# Access Compliance Report

## Public Rights-of-Way

### (Curb Ramps)

Intersection ID: 8368	Main Street: HONDURES_DR	Cross Street: W_SUGAR_CREEK_RD	Location: SW
ADA ID: 9106B9854A64	Ramp Type: ParaDiag	Initial Pass/Fail: Fail	Overall Compliance: No
Codes/Mitigation Info/Possible Solution		Field Measurements/Component Compliance	
Severity Score: 48.75

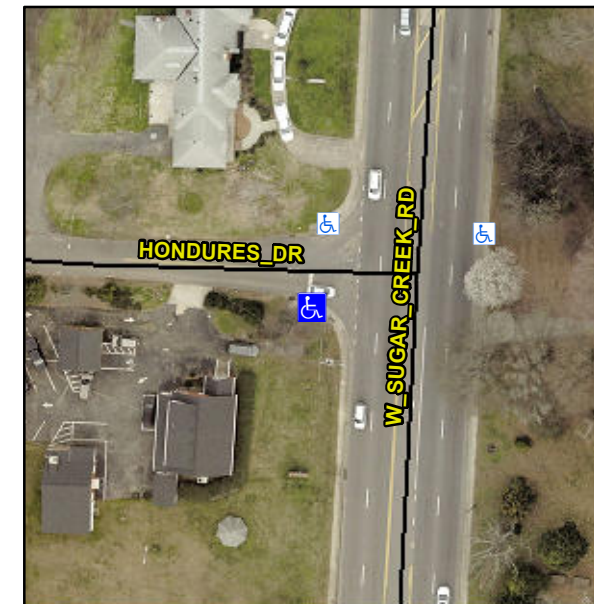
**LT RP < 5%**

**R304.5.1, R304.5.3, R304.3.2**

Compliance	Description	Data	Compliance	Description	Data
N/A	Ramp Length LT (in)	56.0	N/A	Ramp Length RT (in)	59.0
No	Ramp Width LT (in)	26.0	No	Ramp Width RT (in)	32.0
Yes	Ramp Slope LT (%)	1.6	No	Ramp Slope RT (%)	11.7
No	Ramp XSlope LT (%)	2.8	Yes	Ramp XSlope RT (%)	1.6
N/A	Landing Length (in)	N/A	N/A	DWS Provided?	N/A
N/A	Landing Width (in)	N/A	N/A	DWS Contrast?	N/A
N/A	Landing Slope (%)	N/A	N/A	DWS Length (in)	N/A
N/A	Landing X Slope (%)	N/A	N/A	DWS Full Width?	N/A
N/A	Landing Curb? (Y/N)	N/A	N/A	DWS Offset (in)	N/A
N/A	Shared Landing?	N/A			
N/A	Gutter Ponding?	N/A	N/A	Gutter Slope (%)	N/A
N/A	Gutter Lip Ht (in)	N/A	N/A	Gutter X Slope (%)	N/A
N/A	Painted X Walk1?	No	N/A	Painted X Walk2?	No
	X Walk 1 Direction	To E		X Walk 2 Direction	To N
N/A	X Walk 1 Width (in)	N/A	N/A	X Walk 2 Width (in)	N/A
	X Walk 1 Slope (%)	1.1		X Walk 2 Slope (%)	2.3
	X Walk 1 X Slope (%)	2.2		X Walk 2 X Slope (%)	2.5
N/A	Ramp inside XWalk1?	N/A	N/A	Ramp inside XWalk2?	N/A

**Remove & Replace Curb Ramp With Two New Directional Ramps or Equivalent.**
